UHCC - PC42 Hearing

Pinehaven Stream – Flood Mapping Audit 2015

Save Our Hills (Upper Hutt) Inc.

Michael Law, Auditor, Beca Report, 13 July 2015, p17

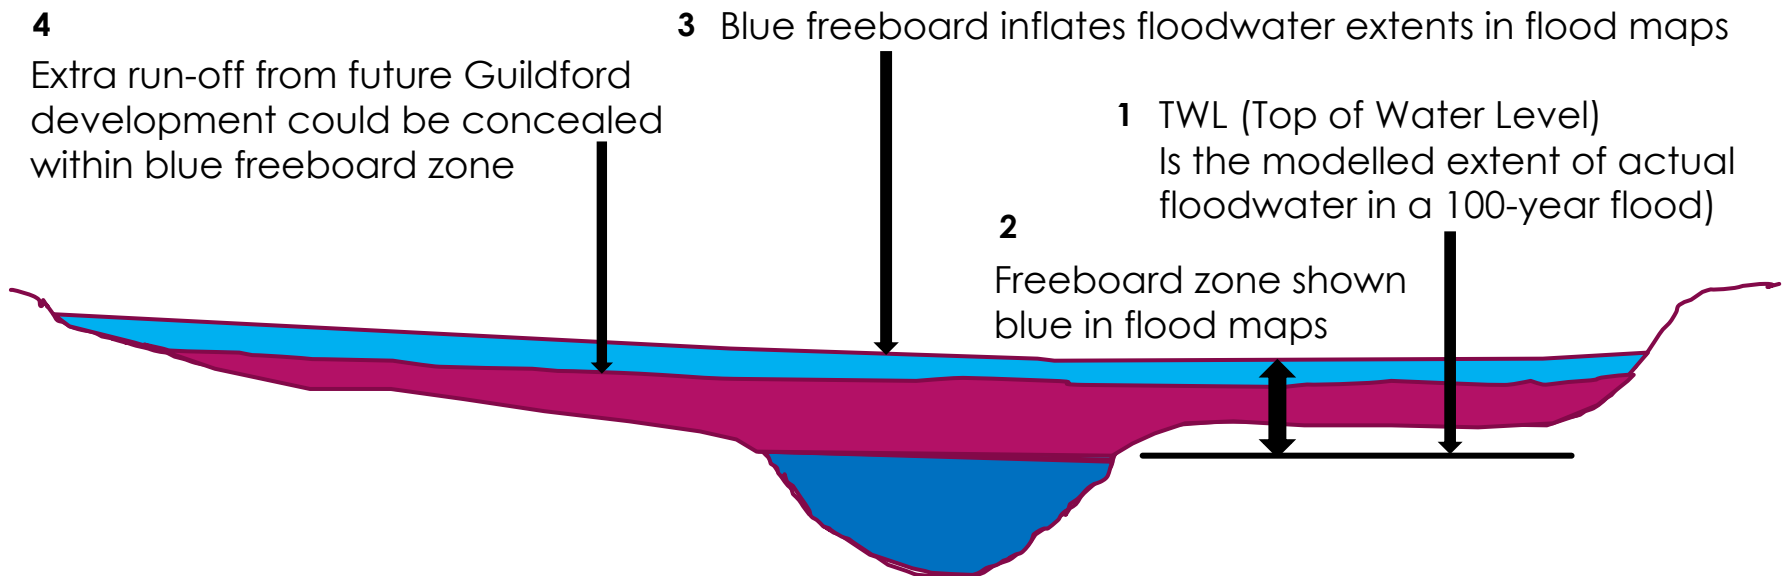
Unsatisfactorily, the 2015 audit suggests... extra run-off from future development can go in the blue freeboard zone without materially affecting the flood maps

"the effects of future development on flood extent are not modelled correctly. However... because there is freeboard incorporated into the results, the flood maps are unlikely to be materially affected by this apparent anomaly."

Is this why HVFMS (GWRC, HCC and UHCC) and their experts and consultants have insisted all along that freeboard must be modelled as floodwater, to accommodate future run-off from the Guildford development?

Figure 5.2 Flood extent elements

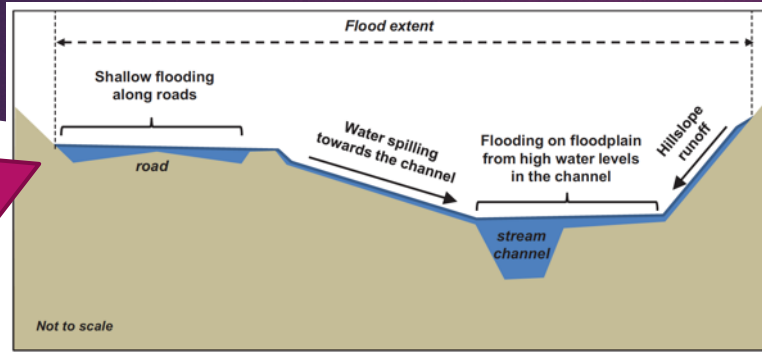
Similar situations to that at Elmslie Road occur at the other three locations identified by SOH's case studies.

The auditor's tale about 27 Elmslie Road [and 3 other cases*] (shown in the auditor's diagram above)

Tampered data:

1. There is no flooding on Elmslie Rd at No. 27 (see GWRC flood map for 27 Elmslie Rd on PC42 Hearing Slide 3.22)
2. Before audit Water on berm is separate from water in channel (data on GWRC graphs, top right of slide).
3. After audit Higher ground removed from berm and berm water shown flowing into channel (altered data, graphs bottom right) to fit the tale in the diagram above.

*Two of the other case studies are NOT like the one above (Dunns St and Pinehaven Reserve) – they're flat. The tale in the above diagram (of water flowing from adjacent hillsides across the property and into the stream) doesn't explain why Dunns St and Pinehaven Reserve flood extents are so wide (and deep) - PC42 Hearing Slides 4.4 & 4.6

Depth x Velocity

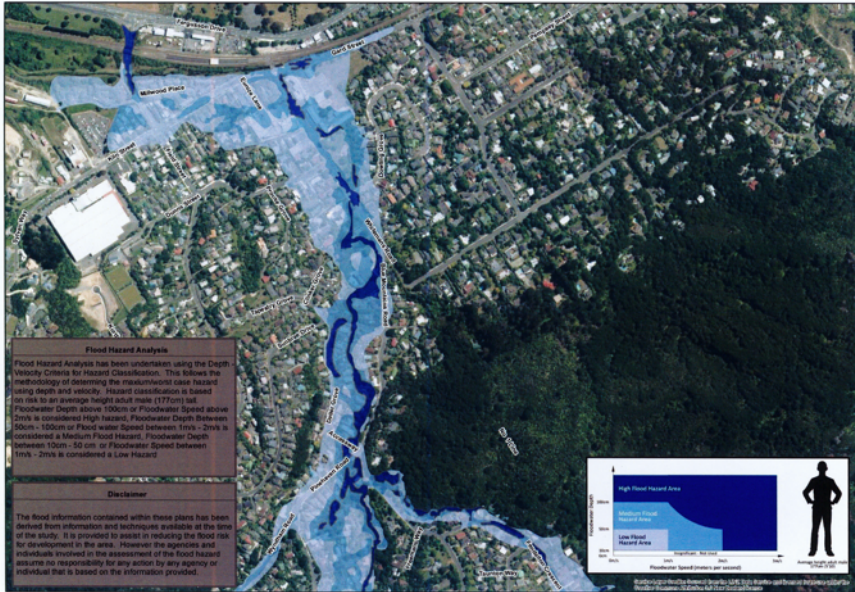
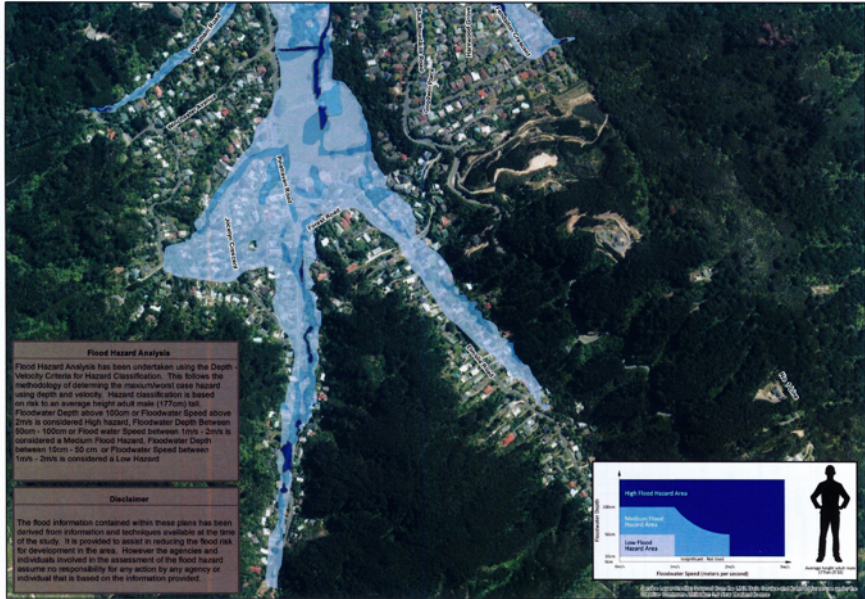
“Flood hazard maps often show the flood hazard calculated as a product of the flood depth and water velocity. This is useful from a hazard assessment perspective to understand potential danger to people, and can be readily calculated from the outputs of 2D hydraulic models. ... such a map would not show any hazard in the buffer zone between the modelled flood extent and the extent including freeboard.”

The flood maps opposite, although using the NSW method, are flawed (Slides 5.6 and 5.7). Assuming the outputs of the flood model are correct (check), rectify the “major issue” by:

- removing blue shading of freeboard
- removing actual water depth <10cm

Resulting flood extent will be less and represent the ‘current situation’ for comparing hydraulic neutrality of future developments (check).
